# Access Compliance Report

## Public Rights-of-Way

### (Curb Ramps)

Intersection ID: 14639	Main Street: ORCHARD RIDGE DR	Cross Street: SPLIT RAIL LN	Location: NE
ADA ID: C95446564F72	Ramp Type: PerpDiag	Initial Pass/Fail: Fail	Overall Compliance: No
Severity Score: 26.25			
Codes/Mitigation Info/Possible Solution		Field Measurements/Component Compliance

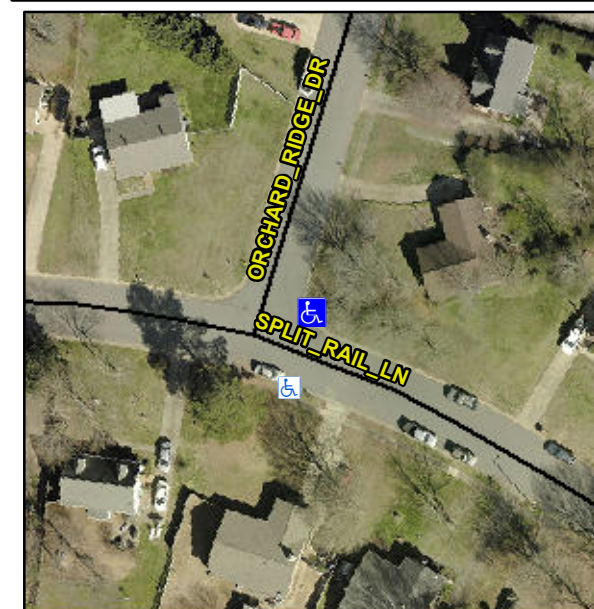
**Not Found, R304.2.2, R304.5.3**

Compliance	Description	Data	Compliance	Description	Data
N/A	Ramp Length (in)	48.0	No	Ramp Slope (%)	14.4
Yes	Ramp Width (in)	53.0	No	Ramp XSlope (%)	4.2
N/A	Flare Type LT	N/A	N/A	Flare Type RT	N/A
N/A	Flare Slope LT (%)	N/A	N/A	Flare Slope RT (%)	N/A
N/A	Flare Traversable LT?	N/A	N/A	Flare Traversable RT?	N/A
N/A	Landing Length (in)	N/A	N/A	DWS Provided?	N/A
N/A	Landing Width (in)	N/A	N/A	DWS Contrast?	N/A
N/A	Landing Slope (%)	N/A	N/A	DWS Length (in)	N/A
N/A	Landing X Slope (%)	N/A	N/A	DWS Full Width?	N/A
N/A	Landing Curb? (Y/N)	N/A	N/A	DWS Offset (in)	N/A
N/A	Shared Landing?	N/A			
N/A	Gutter Ponding?	N/A	N/A	Gutter Slope (%)	N/A
N/A	Gutter Lip Ht (in)	N/A	N/A	Gutter X Slope (%)	N/A
N/A	Painted X Walk1?	No	N/A	Painted X Walk2?	No
	X Walk 1 Direction	To NW		X Walk 2 Direction	To SW
N/A	X Walk 1 Width (in)	N/A	N/A	X Walk 2 Width (in)	N/A
	X Walk 1 Slope (%)	3.8		X Walk 2 Slope (%)	0.9
	X Walk 1 X Slope (%)	7.2		X Walk 2 X Slope (%)	2.8

N/A	Ramp inside XWalk1?	N/A	N/A	Ramp inside XWalk2?	N/A
	Road Slope (%)	9.1	N/A	Clear Space?	N/A
	Road X Slope (%)	1.2	N/A	Clear Space to XWalk (in)	N/A
N/A	Any Obstructions?	N/A	N/A	Storm Grate/Utility Hazard?	N/A
	Obstruction Type			Storm Grate/Utility Type	
		N/A			N/A
		Yes		Surface Condition? (G/P)	Good

**Remove & Replace Curb Ramp With Two New Directional Ramps or Equivalent.**
